## **Addendum #01 for RFB #918604-01**

Project Name: DHS CC Strategic Space Planning Hoover 3rd Floor Dept of Admin Services

Date: September 11, 2024

Addendum #1:

SHEET NUMBER  
**A-601**

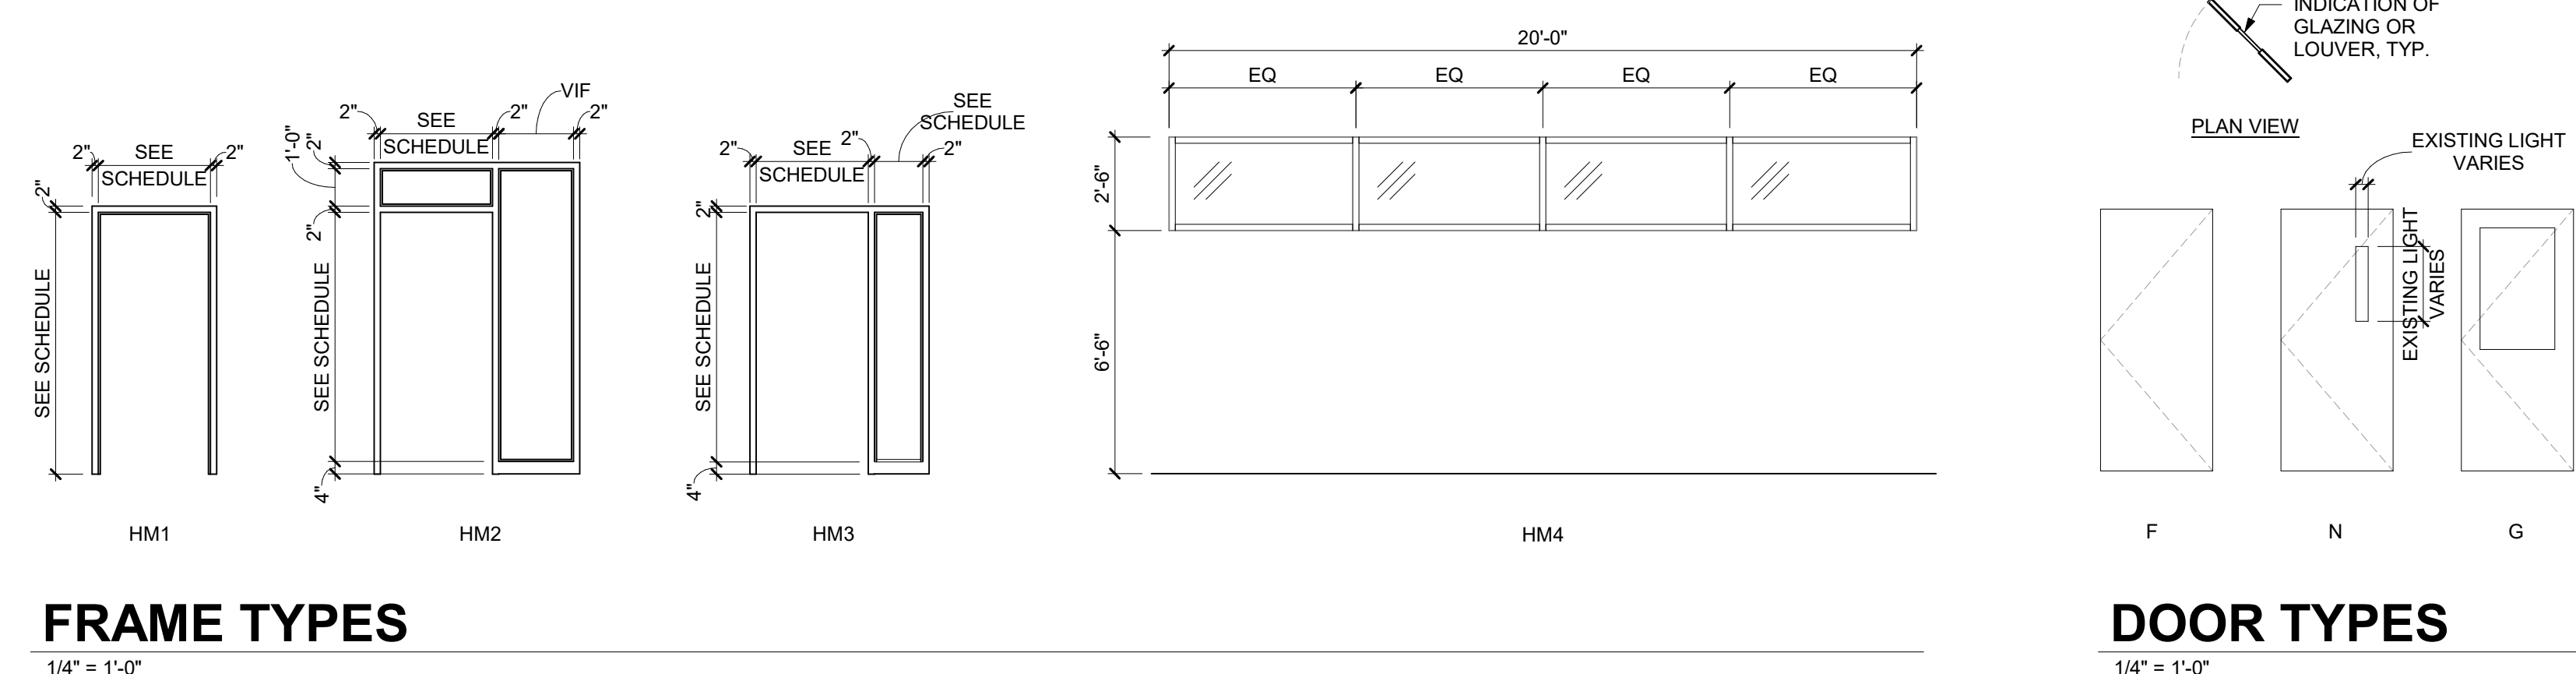
1. Questions Received from contractors (2 Pages)
2. Clarifications on Drawing Sheet A-601 (1 Page)
3. Meeting Minutes: RFP Pre-Proposal Meeting held on 2/27/2024 (10 Pages)
4. 003126 - Existing Hazardous Material Information (31 Pages)

\* EXISTING DIRECTIONAL, INFORMATIONAL, AND ROOM SIGNAGE TO BE REMOVED, SALVAGED, & REINSTALLED, TYP. SEE PHOTO ABOVE FOR REFERENCE.

\* NEW SIGNAGE TO MATCH EXISTING (MATERIAL, SIZE, FONT, ETC). SEE PHOTO ABOVE FOR REFERENCE.
